## **Core Bus Corridor 8: Clondalkin to Drimnagh - Preliminary Submission**

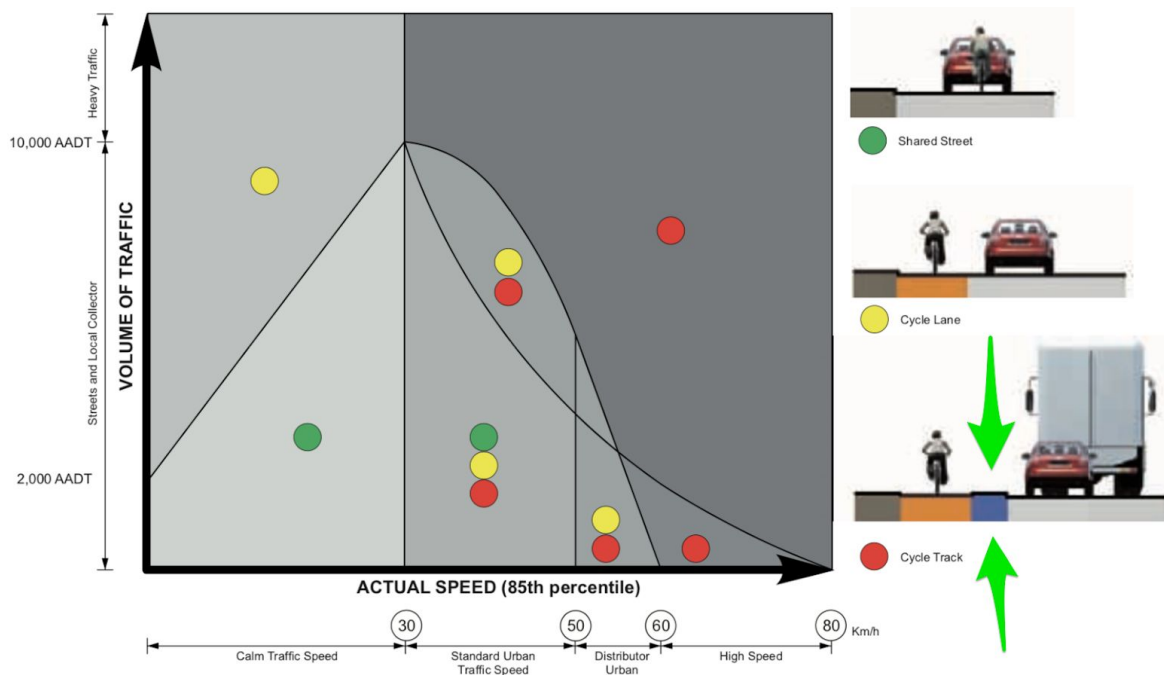
The biggest issue for cyclists in this area will be the large number of HGVs. For example, special attention will need to be given to the how HGVs will cross the cycle tracks to enter premises so that cyclists are not placed in the blind-spot of HGVs. Using

the buffer space side road entry design from section 2.7.2 below will help to mitigate this problem.

*5 Lamps Junction along North Strand - Junction Design Template*

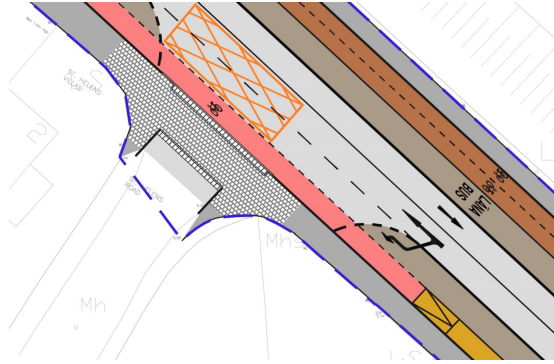
This form of junction design has been achieved along the soon to be constructed North Strand/Fairview cycle route project from Dublin City Council and the NTA. It uses a modified version of the protected junction design. The protected junction design also allows for right hand turns for cyclists.

The junction design also segregates pedestrians and cyclists by providing parallel crossings and designated spaces. This would eliminate shared spaces for pedestrians and cyclists. Shared spaces are disliked by pedestrians, cyclists and by people with disabilities. Parallel crossings also mean that cyclists don't have to use islands in the middle of the road that frequently are too small for bikes to easily manoeuvre around.

### 2.9.1 Bus Stop Locations

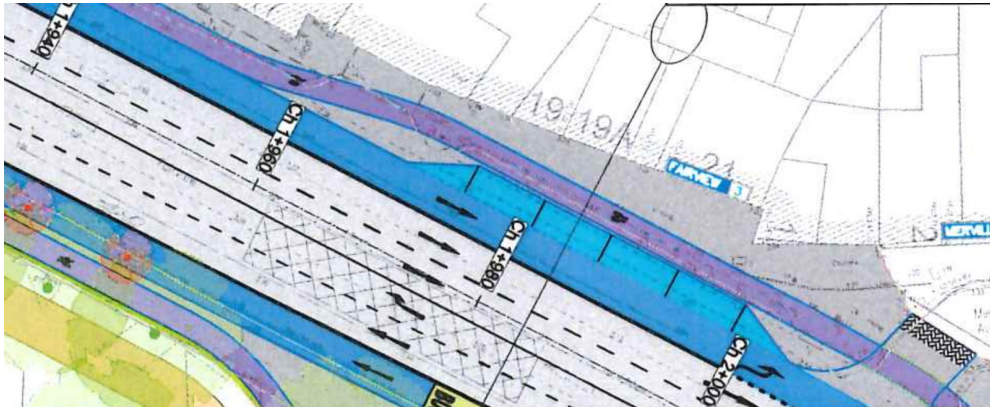
There is a strong case to be made for the rationalisation of bus stop locations. We strongly urge the review of bus stop locations and frequency. This will ensure greater efficiency of the bus service but also allow for greater consideration of the preferred bus stop bypass design for safety of all commuters.
